**MARCH 15<sup>TH</sup>, 2016**

*Project:* **Oak Hollow Master Development Plan Amendment**  
*Applicant:* Dylan Young / Fieldstone Homes  
*Request:* Master Development Plan Amendment  
*Type of Action:* Discussion Item; Public Hearing

**ORDINANCE NO. O- -2016**

OAK HOLLOW SUBDIVISION  
 EAGLE MOUNTAIN, UTAH  
 COVER

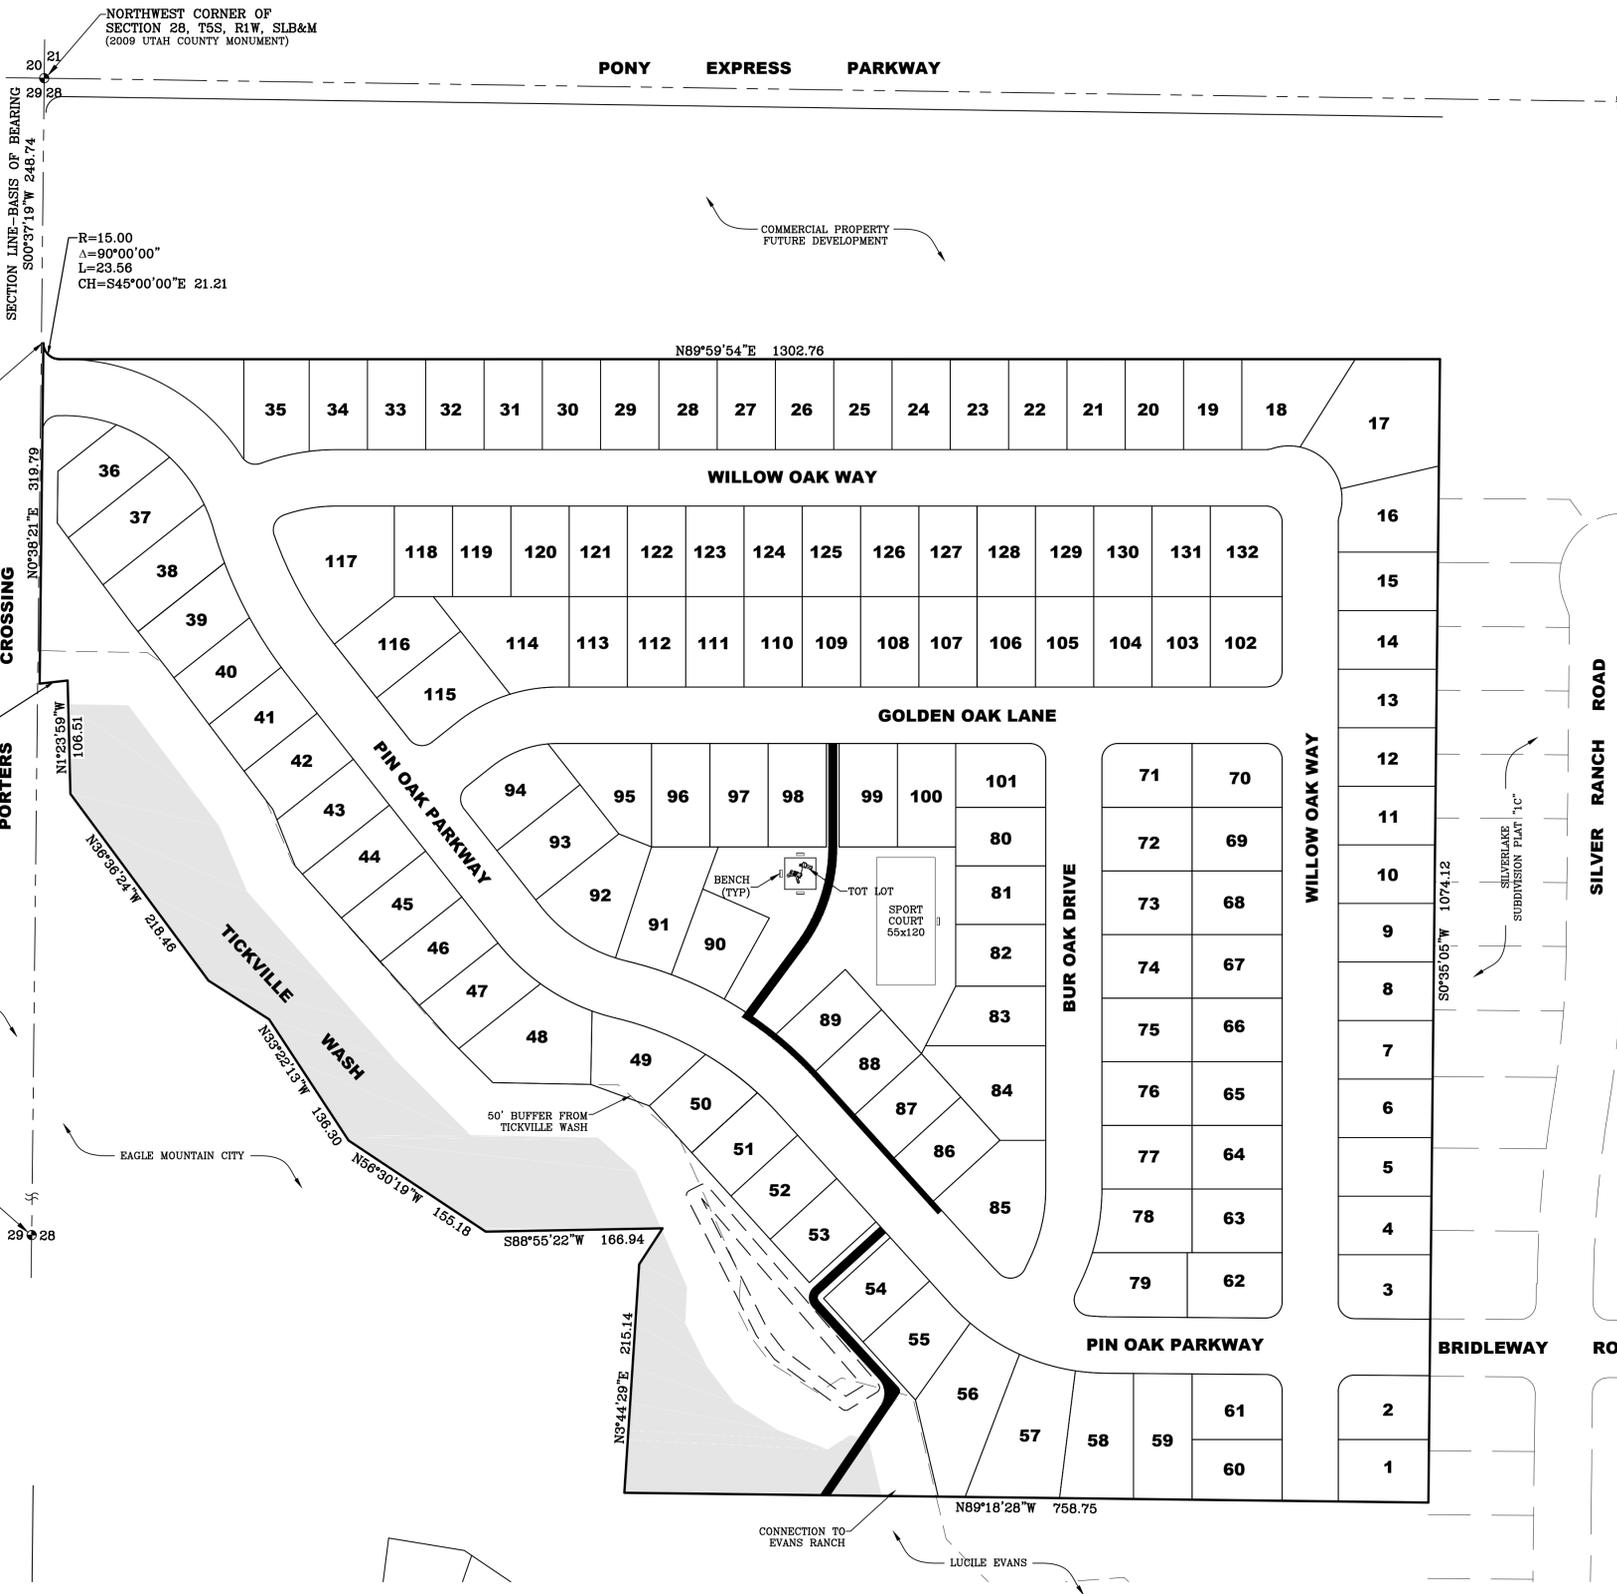
On February 23, 2016, the Planning Commission held a public hearing on the Oak Hollow Master Development Plan Amendment application. The Planning Commission recommended approval of the MDP amendment (5-0) with the following conditions:

1. *The Project must comply with City Dark Sky standards found in chapter 17.56*
2. *Street lights must be paid for before plat recording, and must be installed prior to issuing first Certificate of Occupancy*
3. *The applicant must provide mitigation measures recommended by Traffic Impact Study*
4. *The applicant must submit a Slope Stability Study and provide recommended mitigation measures*
5. *The installed trail must match the trail in the Evans Ranch Development*
6. *Pin Oak Parkway must be renamed to Bridleway Road*
7. *One lot must be removed to open up the park (lot 89 or 90)*

- It should be noted that the applicant is requesting that the Council consider the option of requiring an open, split-rail fence on the backs of all lots abutting the park, rather than removing a lot and reconfiguring the park space.
